Well Name: HUERFANITO UNIT	Well Location: T27N / R9W / SEC 23 / NWSE / 36.5583916 / -107.7546445	County or Parish/State: SAN JUAN / NM
Well Number: 57	Type of Well: CONVENTIONAL GAS WELL	Allottee or Tribe Name:
Lease Number: NMSF078356	Unit or CA Name: HUERFANITO UNIT--PC	Unit or CA Number: NMNM78394A
US Well Number: 3004513473	Operator: HILCORP ENERGY COMPANY

Type of Submission: Notice of Intent	Type of Action: Plug and Abandonment
Date Sundry Submitted: 01/16/2026	Time Sundry Submitted: 07:33
Date proposed operation will begin: 02/02/2026

**HILCORP ENERGY COMPANY**  
**HUERFANITO UNIT 57**  
**P&A NOI**

### Notice of Intent – Plug and Abandonment

## P&amp;A WBD Proposed

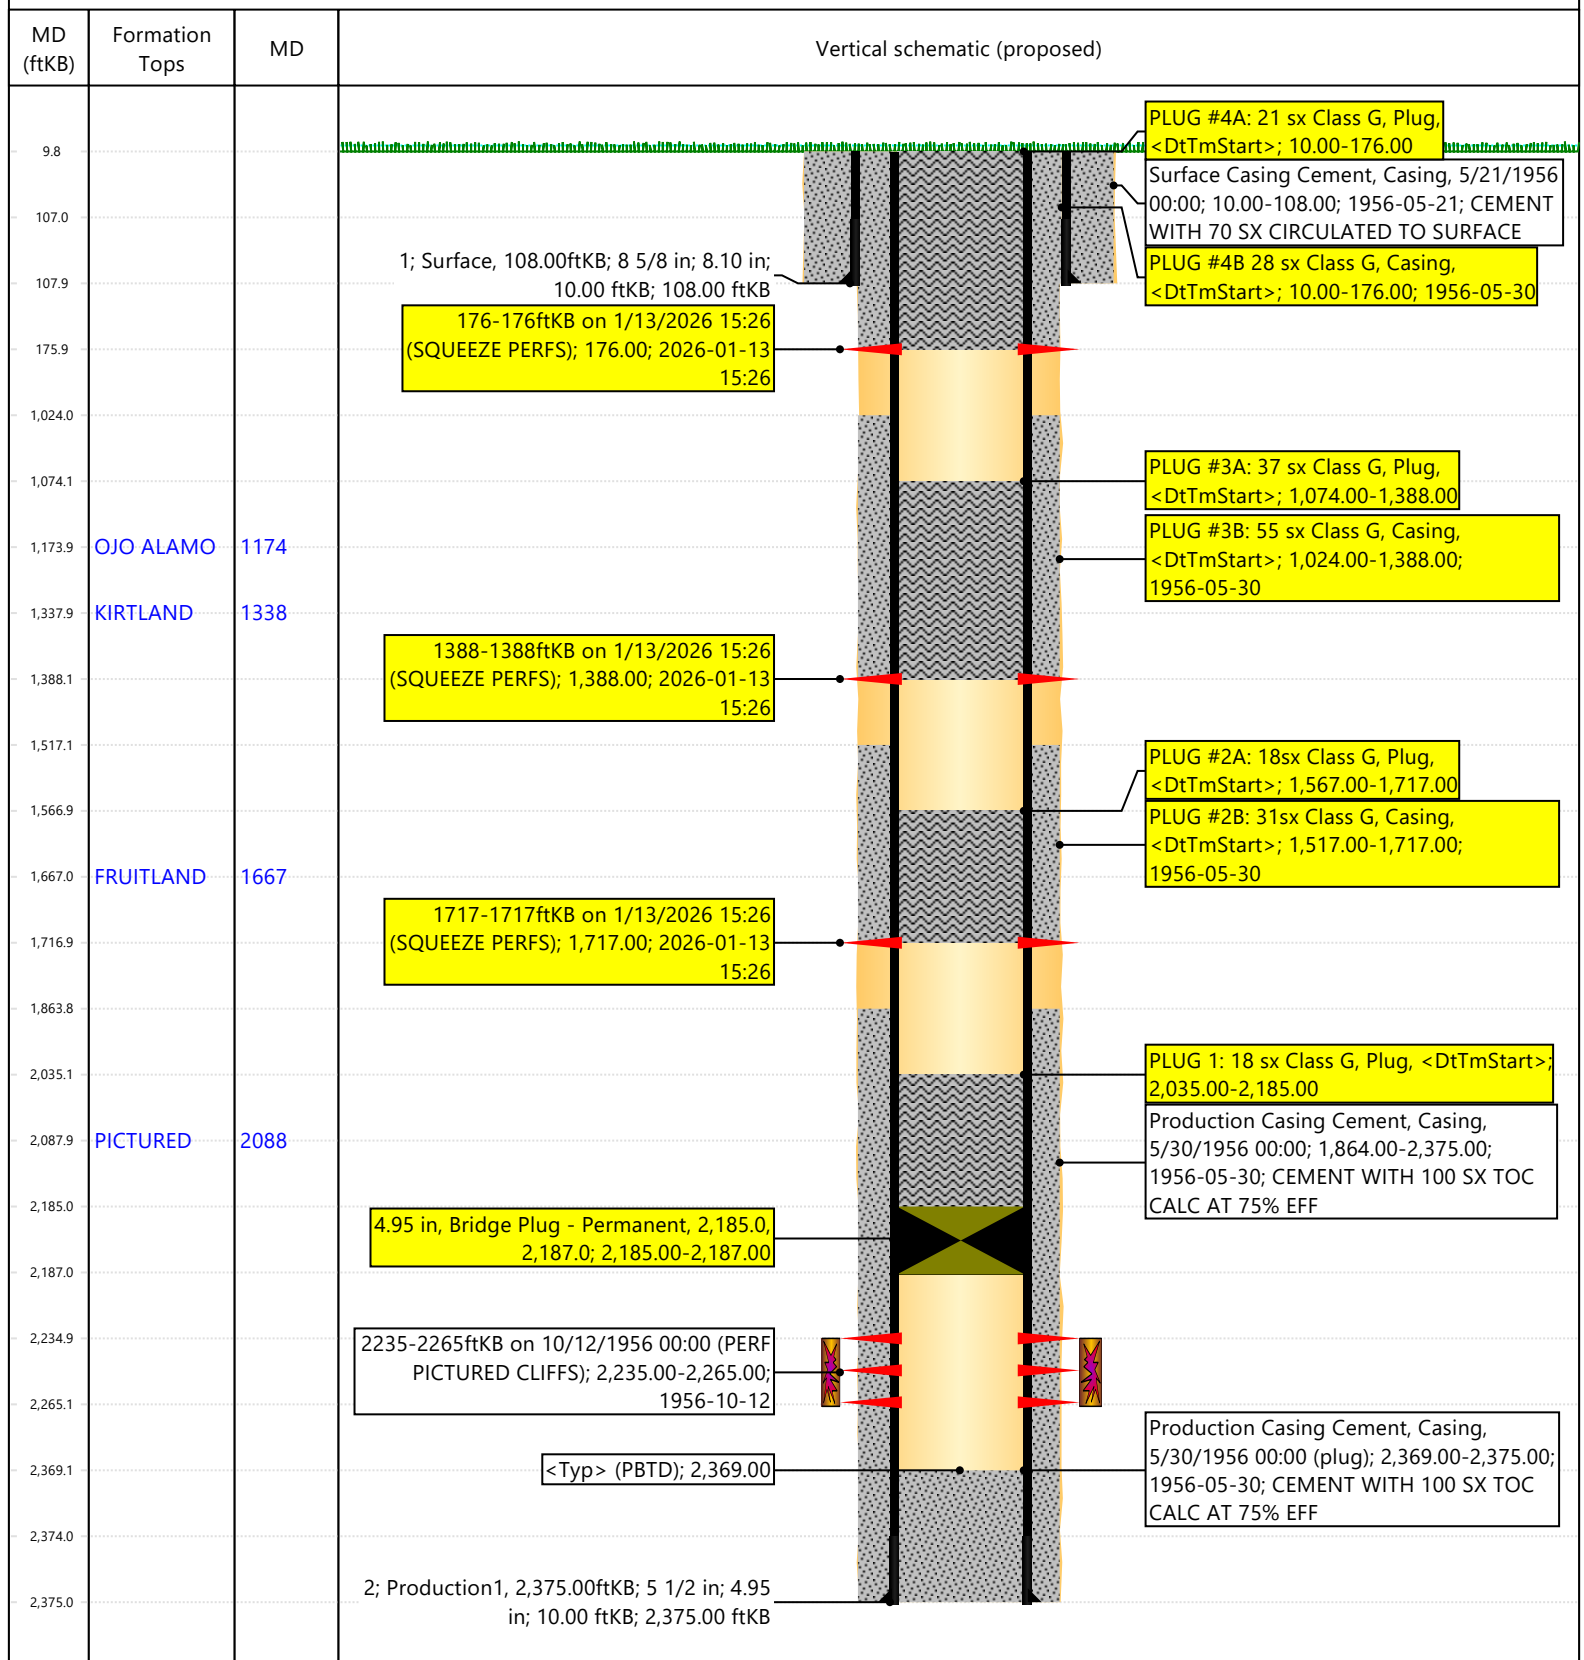
Modify Plug 3. Perforate at and make the BOC 1500' to account for the BLM pick for the Kirtland at 1500' and TOC of plug 2. Alternately alter plug 2 and plug 3 to account for the Kirtland top.

1. Plugging operations authorized are subject to the attached "General Requirements for Permanent Abandonment of Wells on Federal and Indian Lease."
2. The following modifications to your plugging program are to be made:
  - a. Modify Plug 3. Perforate at and make the BOC 1500' to account for the BLM pick for the Kirtland at 1500' and TOC of plug 2B. Alternately alter plug 2 and plug 3 to account for the Kirtland top.
3. **Notification:** Farmington Office is to be notified at least 24 hours before the plugging operations commence at (505) 564 7750.
